Re: Soil, Geology and Geologic Hazard Evaluation  
Meridian Ranch – Rolling Hills Ranch, Filings 1 through 4  
SE of Sunrise Ridge Drive and Rex Road  
El Paso County, Colorado

SITE PLAN/PROPOSED GRADING  
MERIDIAN RANCH - ROLLING HILLS RANCH  
FILINGS 1 - 4  
EL PASO COUNTY, CO.  
FOR: TECH CONTRACTORS

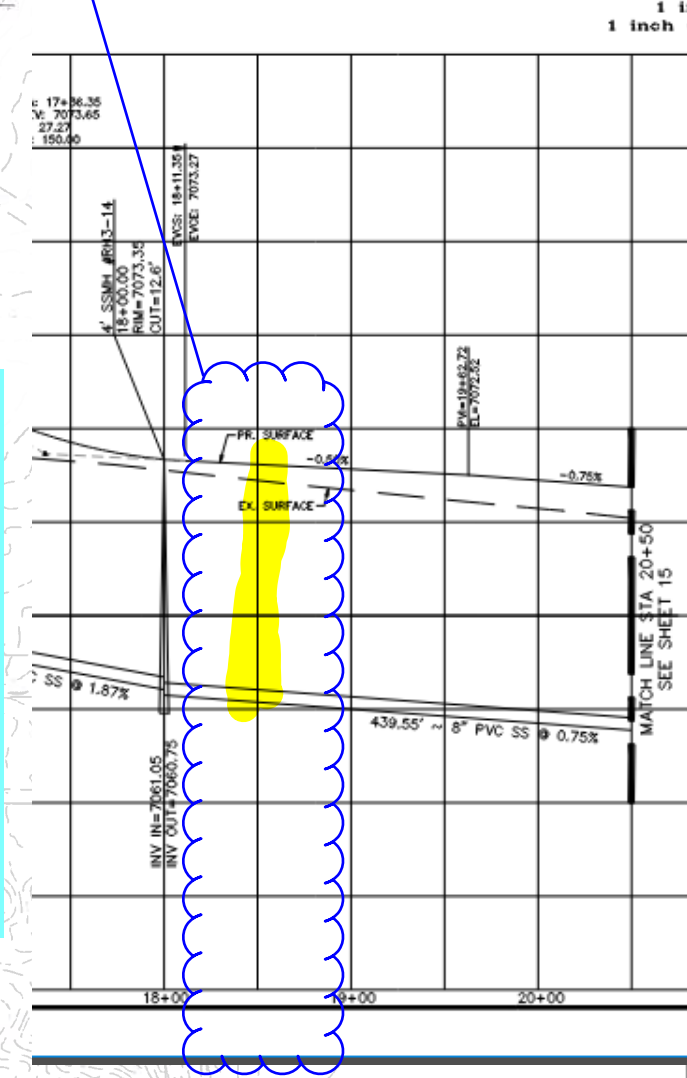
Approximate location of TB24. Groundwater would only be around 2-3ft below finished grade of the road. Snippet of the street profile shown below

Provide mitigation recommendation when groundwater is near the proposed roadway. Identify, if any, specific considerations/mitigations for the underground utilities installed below groundwater elevation?

Update to narrative to identify what the depth from finished ground to ground water where mitigation is required in designing the roadways.

Coordinate with the design engineer to determine the sections of Filing 3 proposed roads that needs mitigation.

See attached letter for engineers response to this comment and updated borings for TH #23 & 33.
